CITY OF ALBUQUERQUE

RE: **Lot 5 Block 9, Volcano Cliffs, Unit 22, SAD 228
6428 Picardia NW
Grading and Drainage Plan
Engineers Stamp Date 8/8/18 (D10D003Q5)**

Based upon the information provided in your submittal received 8/8/18, this plan is approved for Grading Permit.

ENGINEER'S SEAL	LOT 5, BK 9 UN 22 VOLCANO CLIFFS 6428 PICARDIA PLACE	DRAWN BY DEM
DAVID SOULE REGISTERED PROFESSIONAL ENGINEER 14522	GRADING AND DRAINAGE PLAN	DATE 8-7-18
	 1606 CENTRAL AVENUE SE SUITE 201 ALBUQUERQUE, NM 87106 (505) 872-0289	SHEET # C1
8/8/18		JOB #
DAVID SOULE P.E. #14522

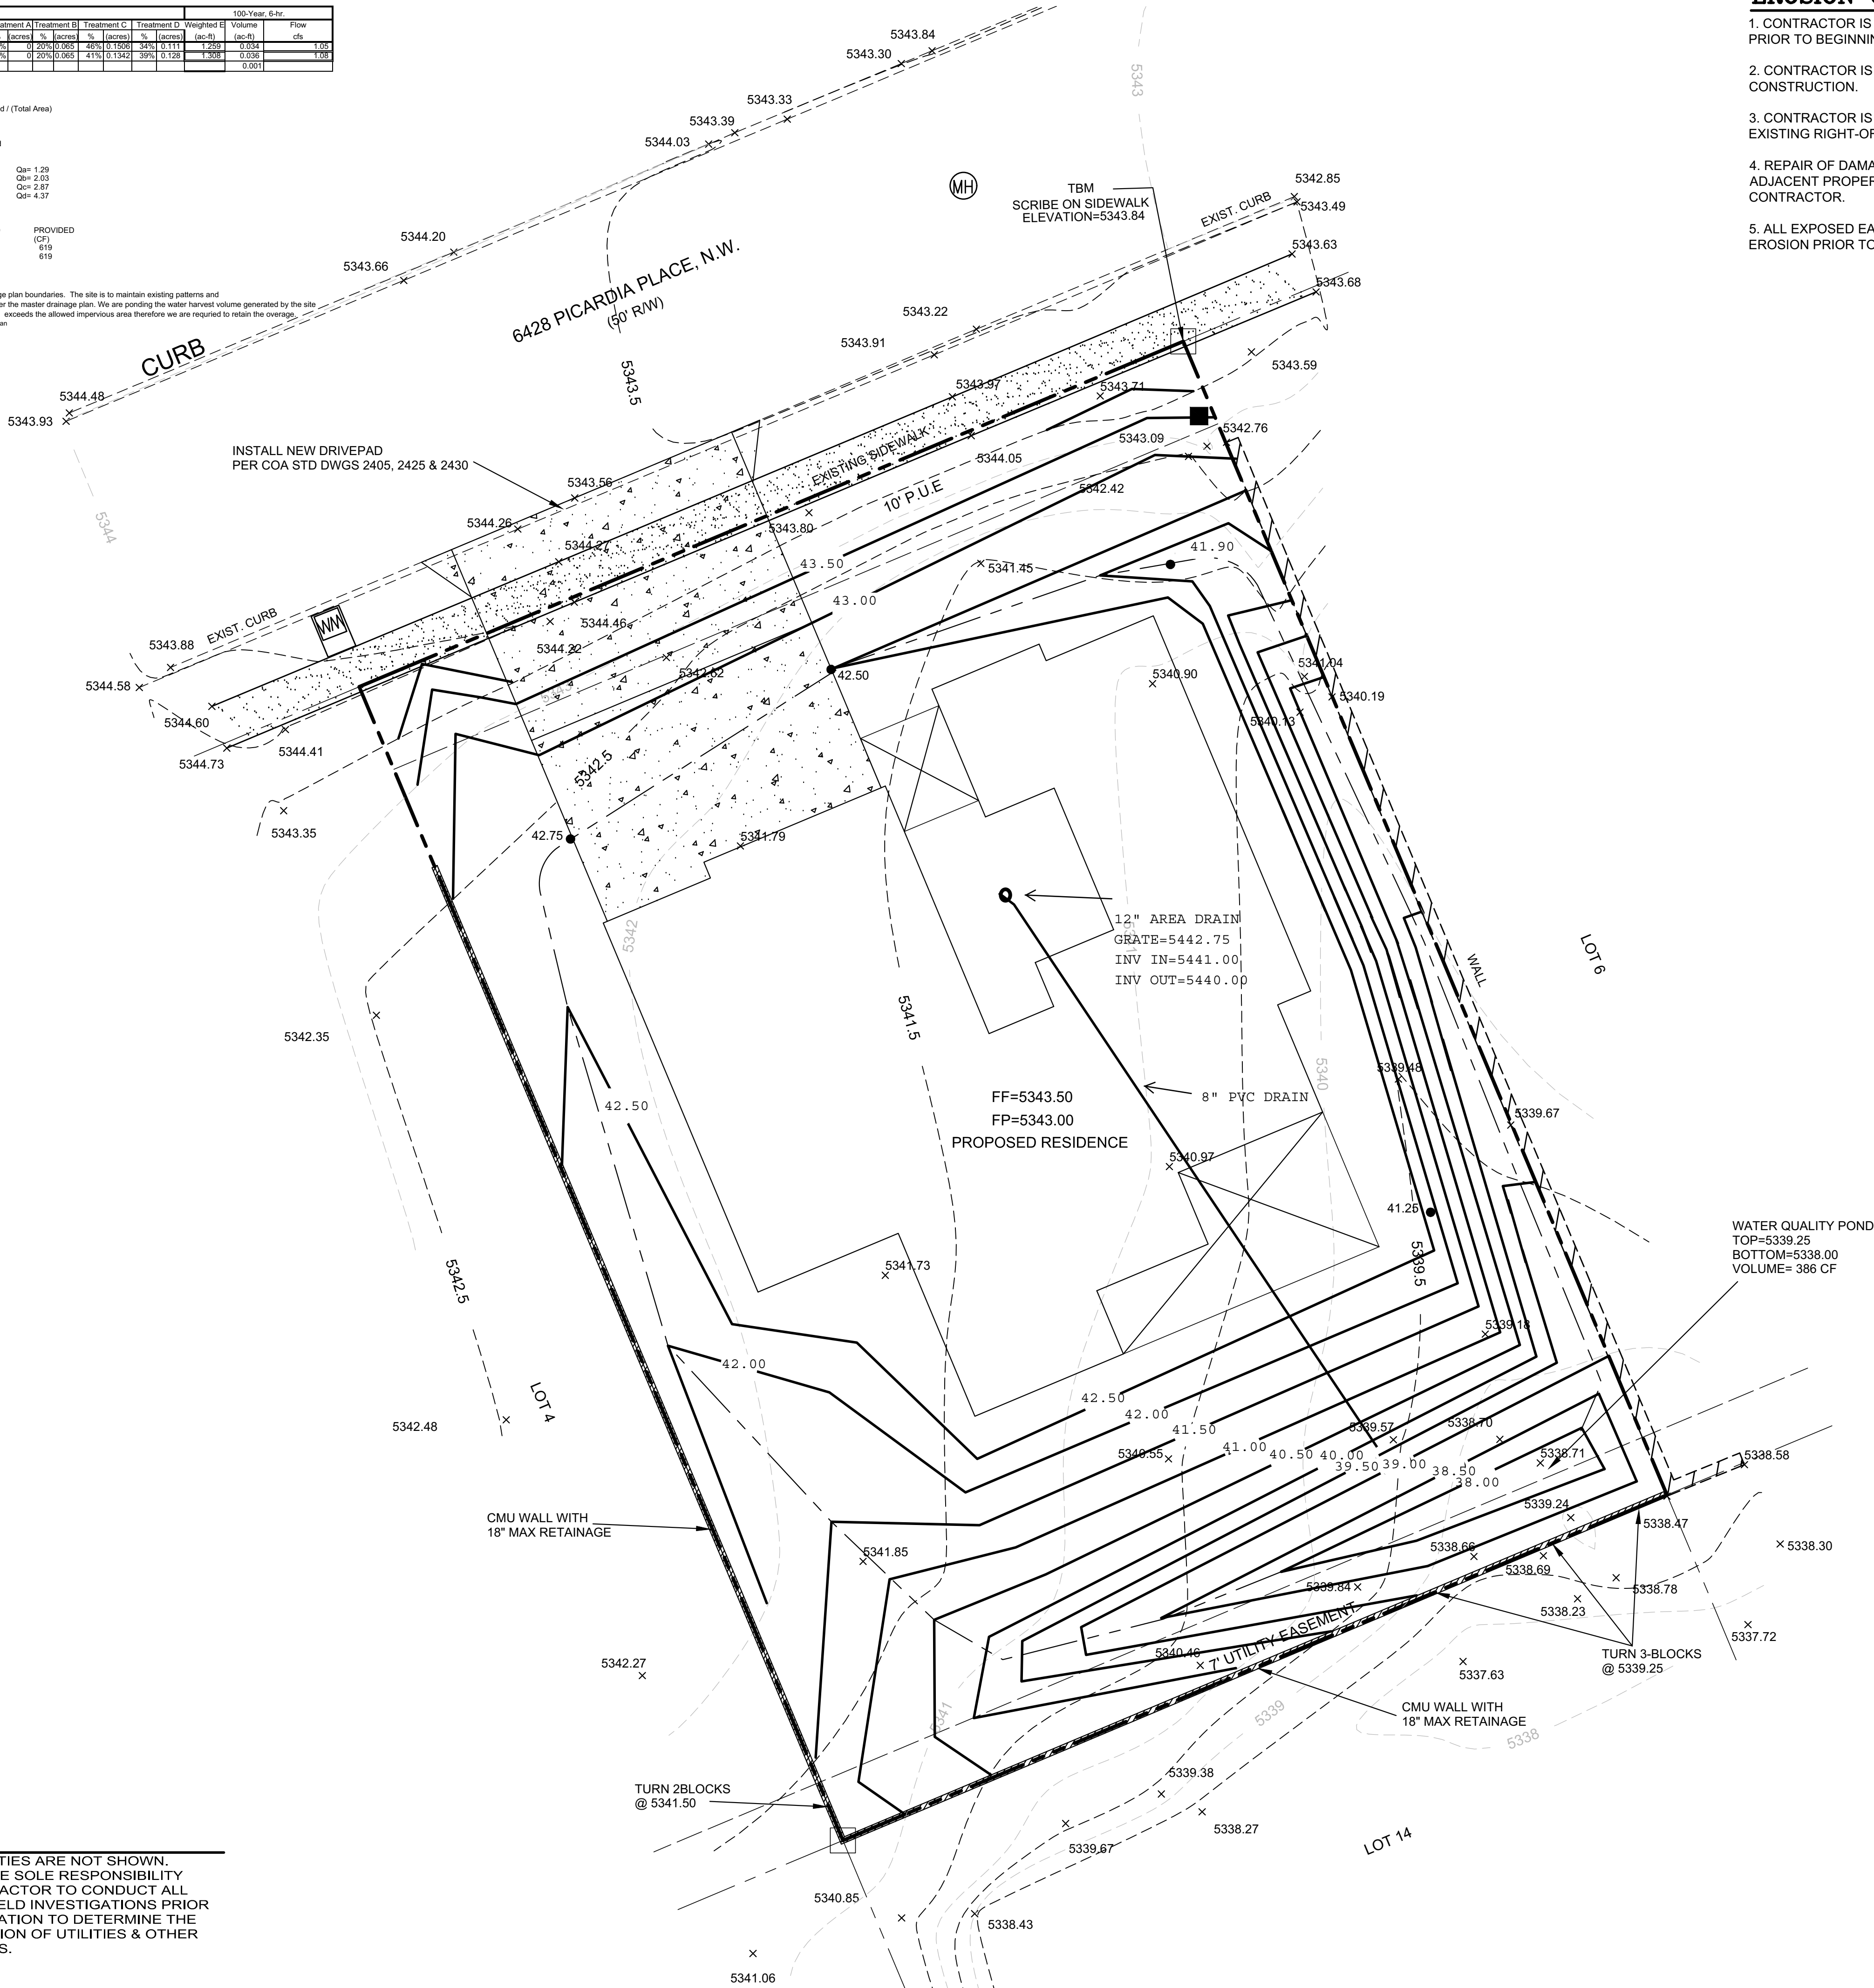
Prior to Building permit approval a Pad Certification will be required, provided by the Engineer or a registered Land Surveyor.

Reiterate to the Owner/Contractor that a separate permit for a garden/retaining wall must be obtained with the approved G&D plan and Pad Certification.

Prior to Certificate of Occupancy release, Engineer Certification per the DPM checklist is required.
